EXECUTIVE ORDER G-70-191-AA

**Relating to Language Correction in
Existing Executive Order G-70-191**

Healy Systems, Inc.

Vapor Recovery Piping Configurations, (Figures 2A-1 - 2A-5)

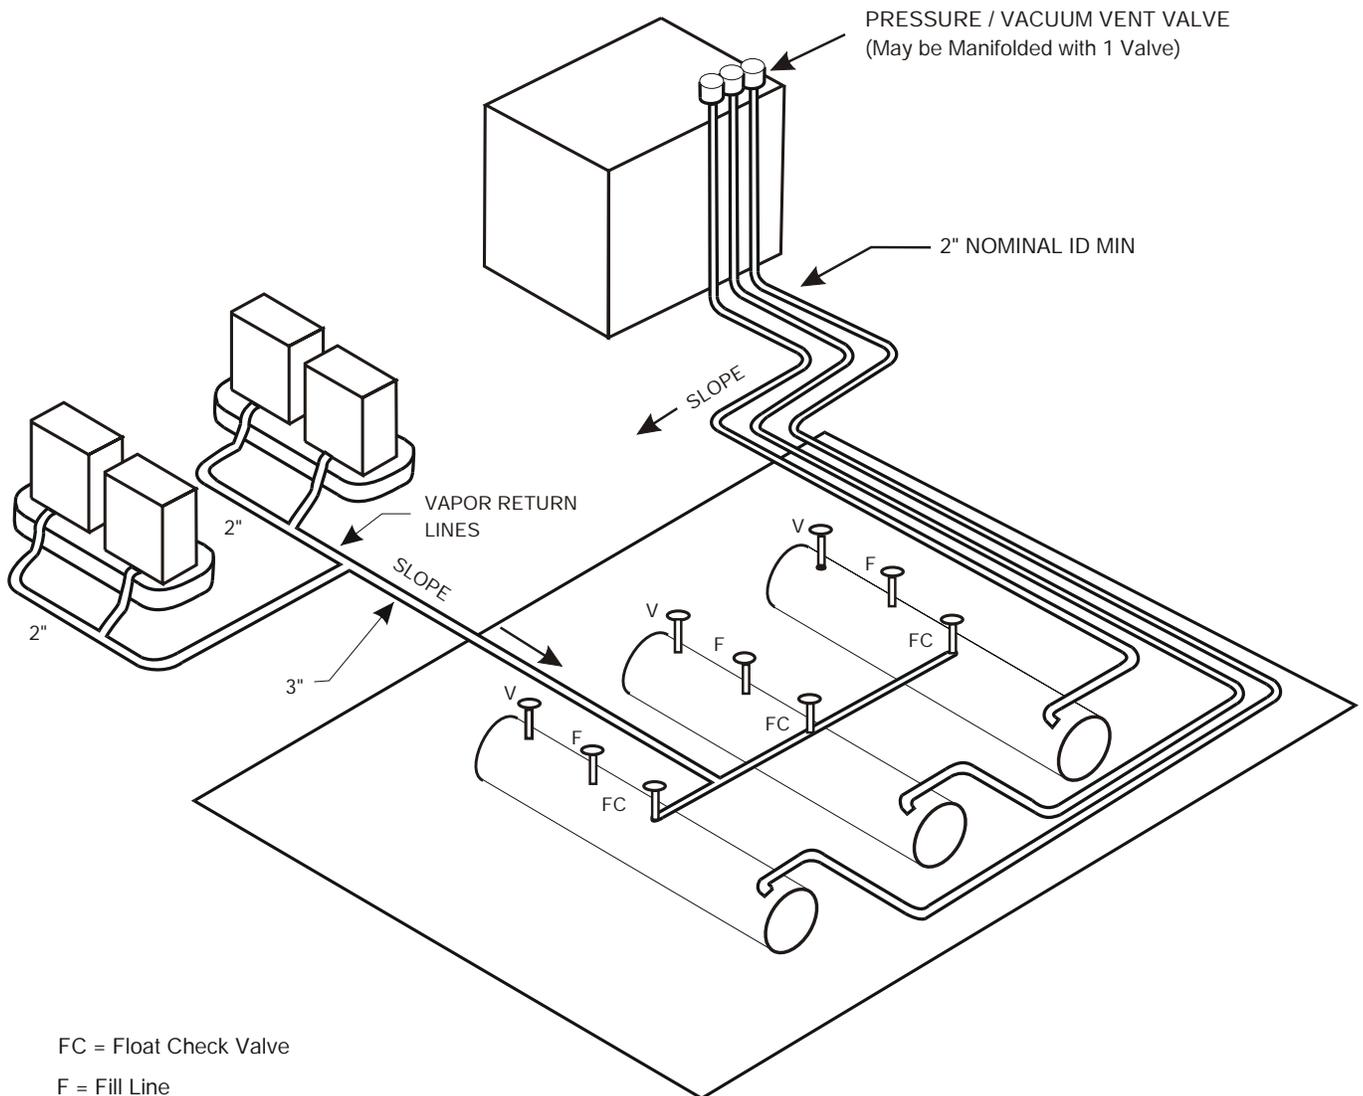
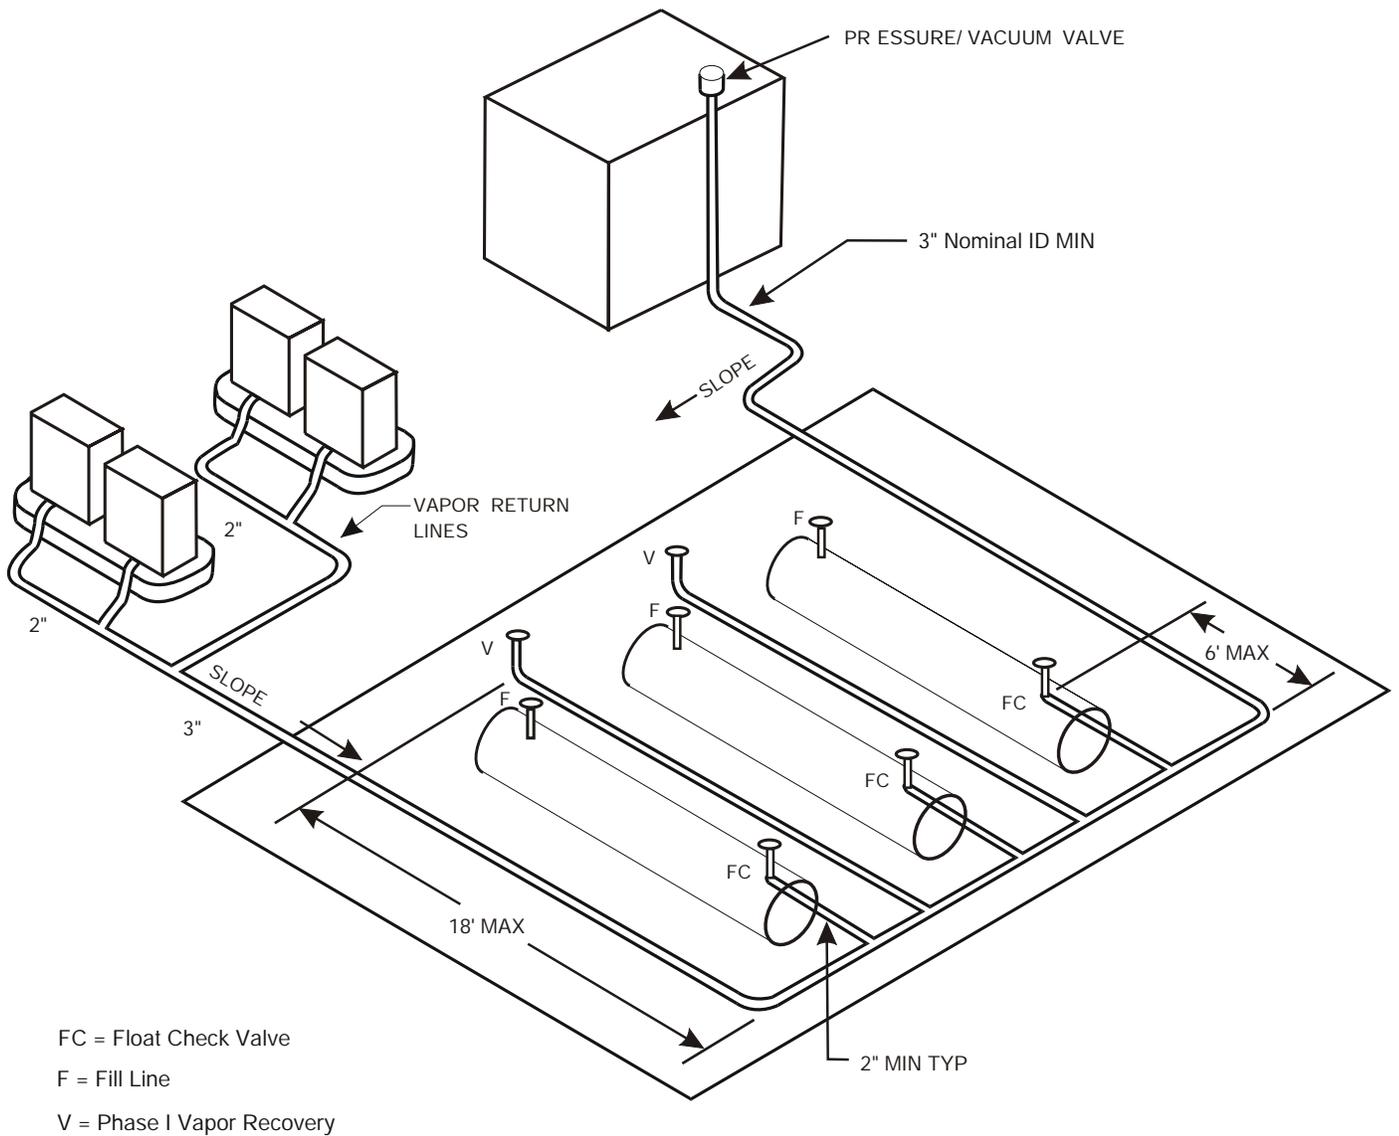
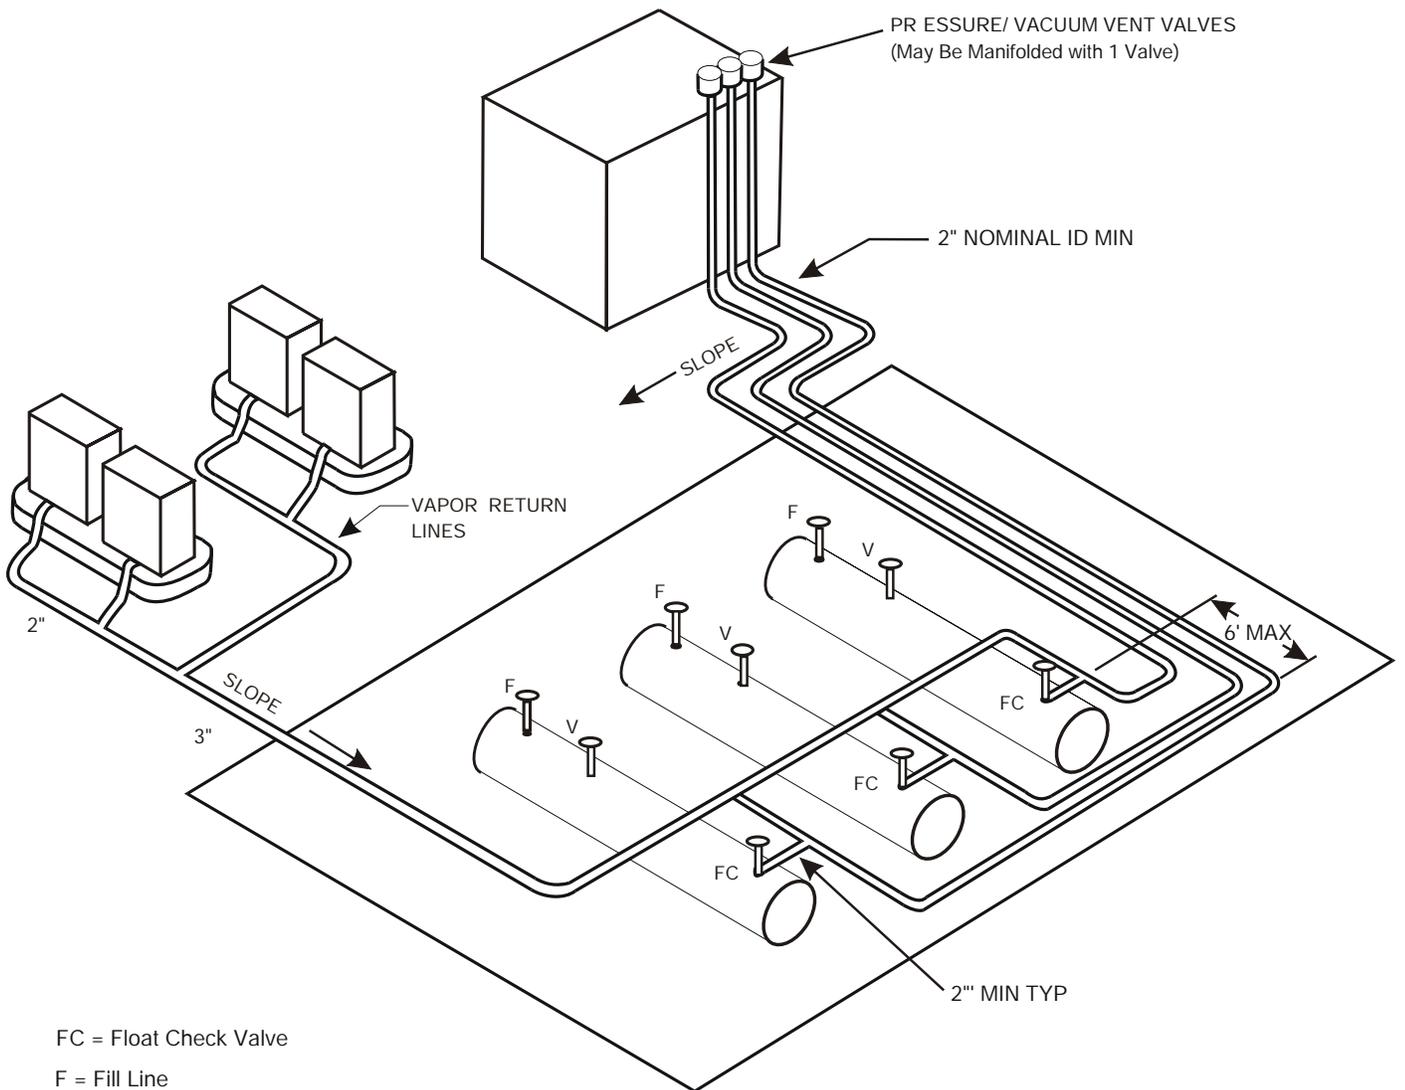
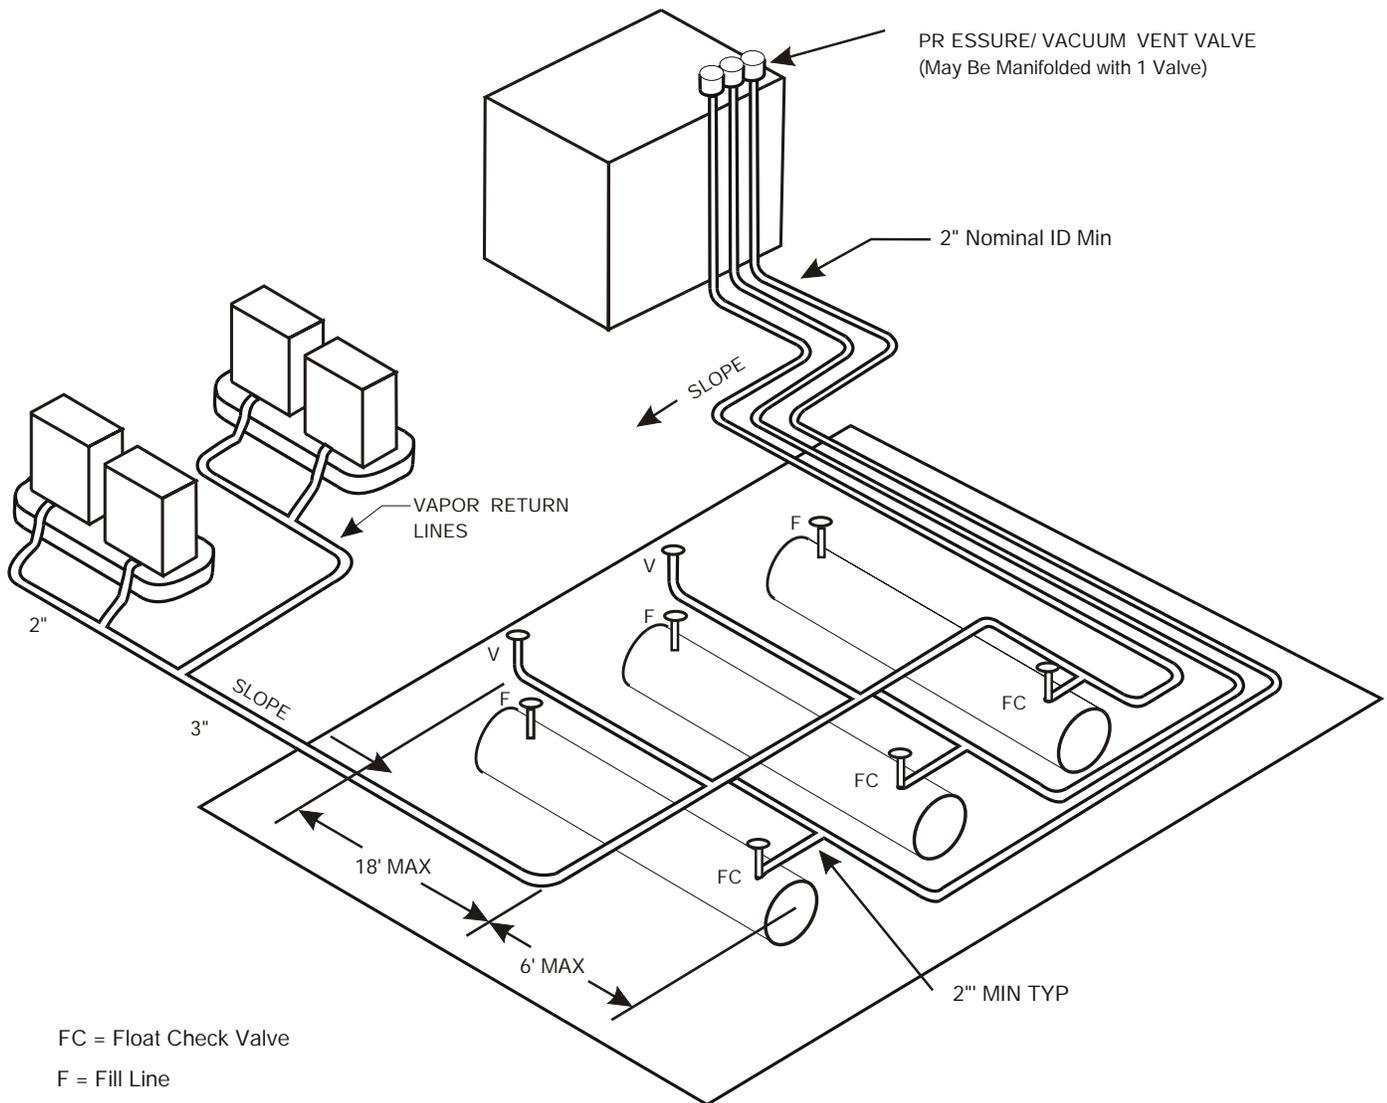
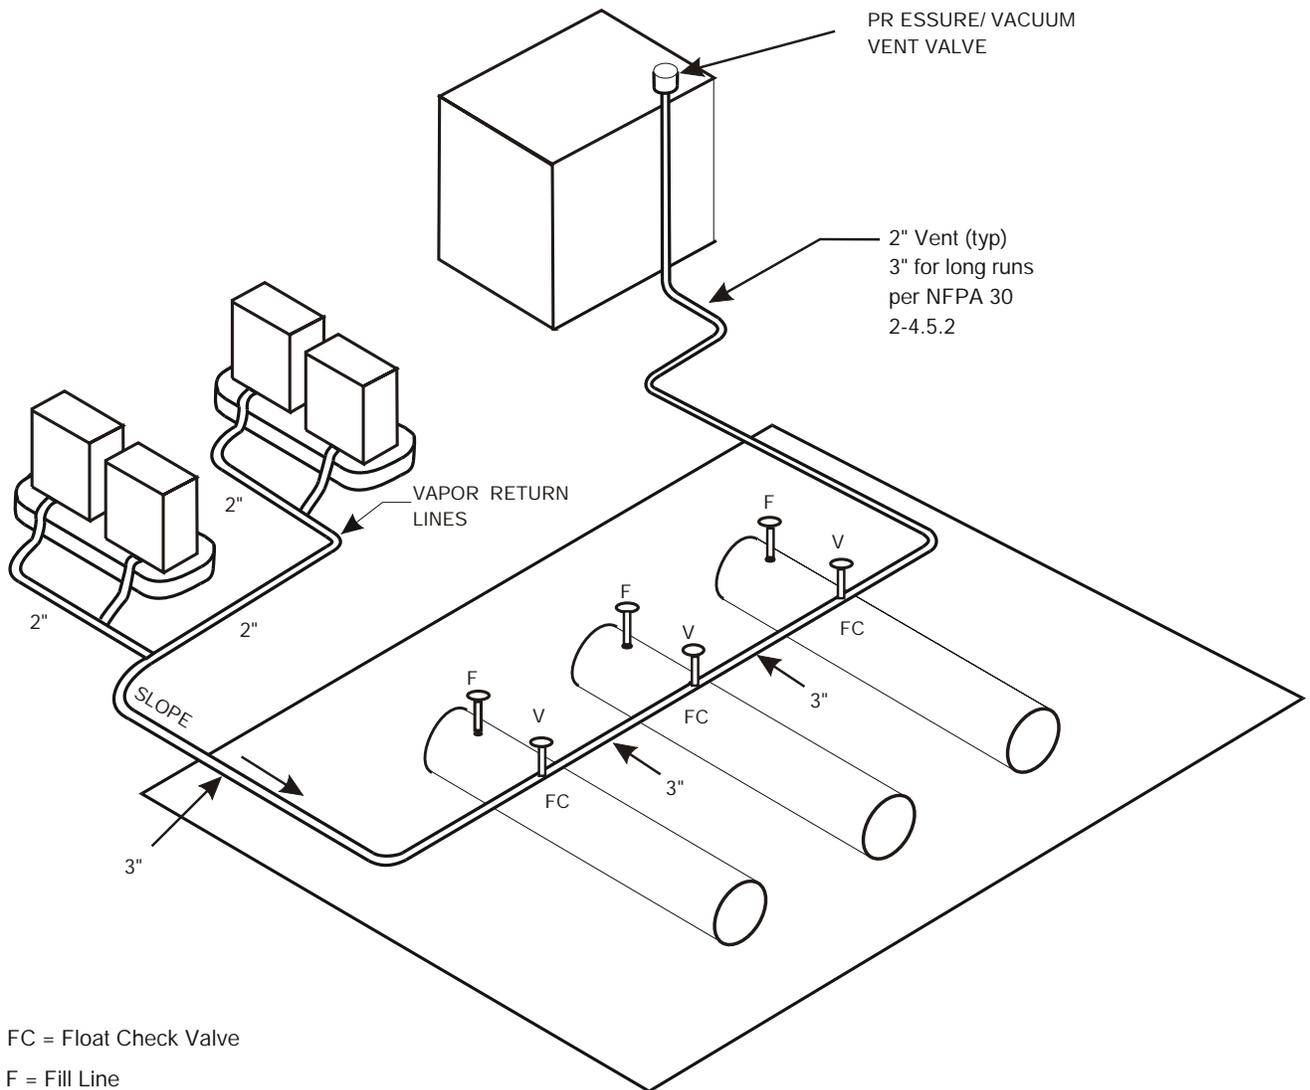
WHEREAS, Executive Order G-70-191 did not correctly describe the Power Level Controls for the Healy/Franklin Electric VP-1000 vapor pump. The language has been modified to accurately reflect the operational characteristics of the Healy/Franklin Electric VP-1000 vapor pump. A nozzle vapor valve verification test procedure and vapor pump operational verification language has been added. Additional language regarding the use of "low-point" condensate traps in the vapor return lines and the use of above ground manifolding of existing station vapor plumbing, increasing the maximum hose length from 13 to 15 ft has also been added;

1. All vapor return and vent lines shall be a minimum 2" diameter from the dispensers to the first main manifold. All lines after the first manifold and back to the underground storage tanks shall be a minimum 3" diameter.

Exception: Smaller vapor lines are not recommended but if pre-existing, may be used providing the pressure drop criteria specified below are met.

2. The maximum allowable pressure drop through the system shall never exceed one-half inch (0.5") water column at 60 SCFH. The pressure drop shall be measured from the dispenser riser to the UST with pressure/vacuum valves installed and with the popped Phase I vapor connection open.
3. All vapor return and vent lines shall slope a minimum of 1/8" per linear foot. A slope of 1/4" per linear foot or more is recommended whenever feasible.
